## TECHNICAL DATA SHEET

**Release Date:** 05-12-2013  
**Model:** Machine codes starting with **32.1xxx.x4x**  
FS Wrapping machines with carriage C4 "Magnetic brake system"

**OLD** N51.5448 (Without cable)  
**NEW** FS3.2714 (With cable, soldered on the potentiometer)  
**NEW** FS3.2663 (With cable, cut feet, soldered on the potentiometer)

**Fig 1 / FS3.2663\_1**

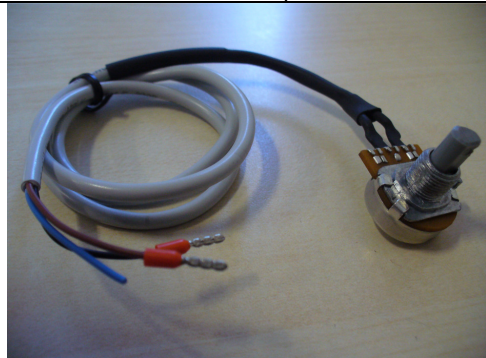
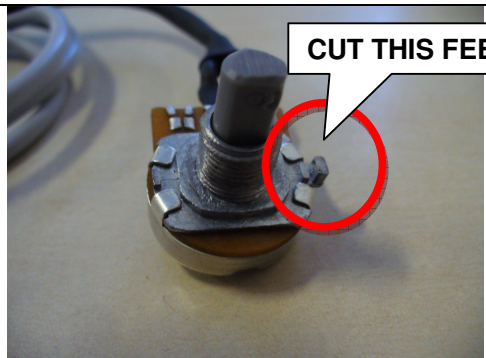
In this "new" version of the Potentiometer "**Fig 1**" we have cut the locking bracket (Check the picture below "**Fig 2**").

This prevents a malfunction, which could occur when the potentiometer has been mounted to firmly on the door of the FS3xx. In "**FIG 3**" you see the potentiometer in original version

The magnetic brake tends to be closed, "high film tension" also with the potentiometer adjusted at a low value.

In the new versions of the machines, the door for the electrical box and closing plate have already been prepared with an additional hole to fit this bracket without problems. A new code "FS3.2663" has been released to ensure easy installation and future required service in case the corresponding hole has not been OEM made.

**FS3.2663** Code for the bracket, with the feet cutted. You have to use this code, in case the corresponding hole in the door or front-plate of the electrical box has not been made.
